**STAFF REPORT
FOR THE HISTORIC REVIEW BOARD**

FILE NUMBER: DR-18-09

REQUEST: Class I Design Review – Modify west side elevation window configuration, as approved in March 2017 (DR-17-01), and a CDC Chapter 58 Variance for siding material

WEST ELEVATION - APPROVED SUBMITTAL

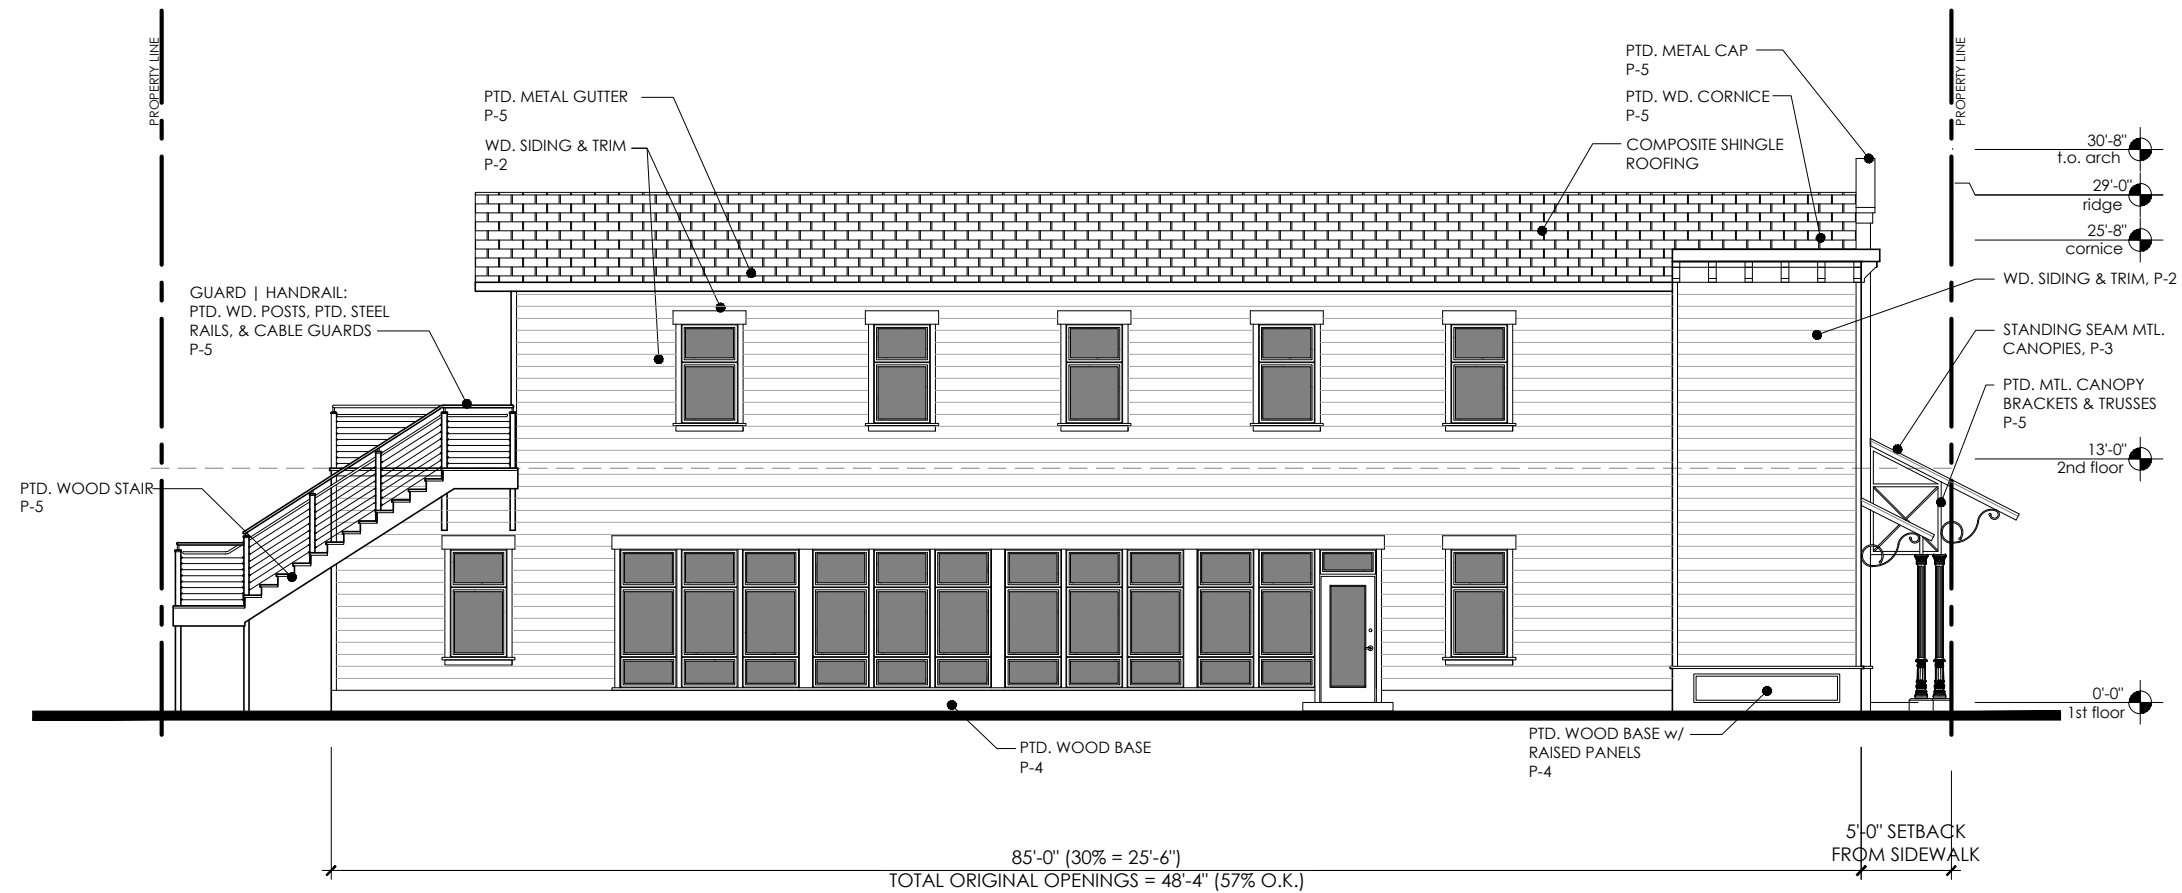
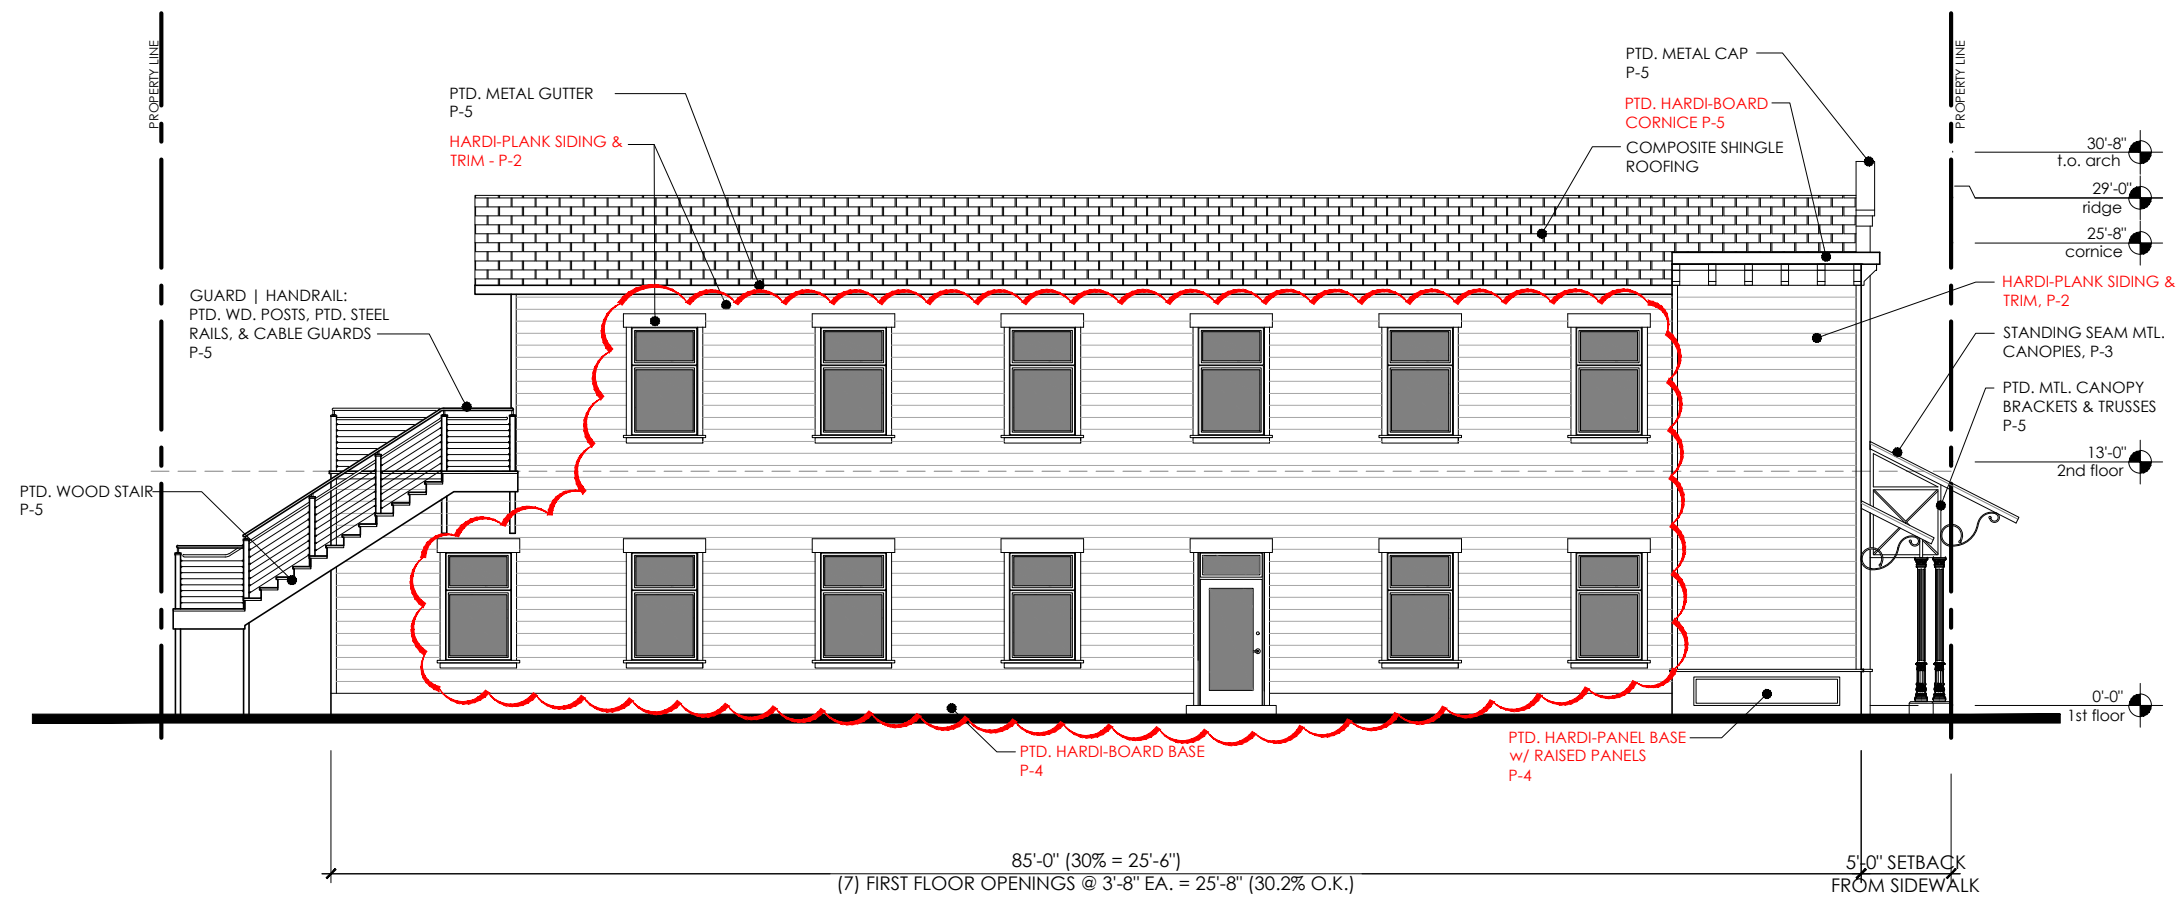
to modify the window configuration on the west side elevation. All proposed windows are double-hung and have a minimum of two lights. The proposed change will result in 30.2% transparency on the west side elevation from the originally approved 59% transparency. This criterion is met.

PROPOSED REVISION (TYPE 1 REVIEW): Per this proposed alteration, the windows on the west elevation will be revised from a single large opening flanked by 2 smaller windows to six evenly spaced windows and a glass man door. The new layout will result in 25'-8" of opening in an 85'-0" of elevation for a total of 30.2%. With this proposed change, the percentage of opening requirement for the side elevation is still met.

Prior Approved West (Side) Elevation

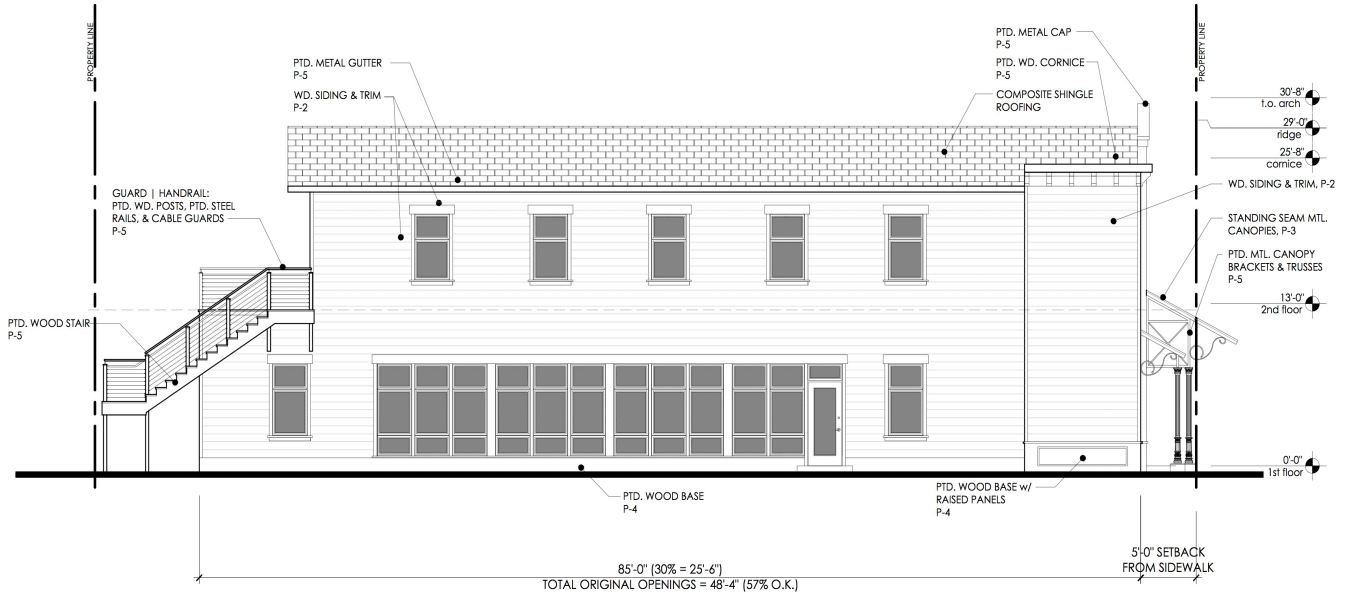
Windows: The applicant was approved to construct this commercial building per DR-17-01 approval. After HRB approvals were obtained, market forces and considerations caused the applicant, a financial services firm who will be the building owner and principal tenant to elect to occupy the upper floor of the building in lieu of the ground floor as originally intended. This will allow the ground floor to be occupied by a variety of tenants, potentially including retail tenants, which would more closely meet the intent of the district. The window changes are limited to the west side elevation and are intended to improve the attractiveness of the interior tenant spaces to retail tenants, who traditionally prefer fewer windows on the non-storefront elevations.
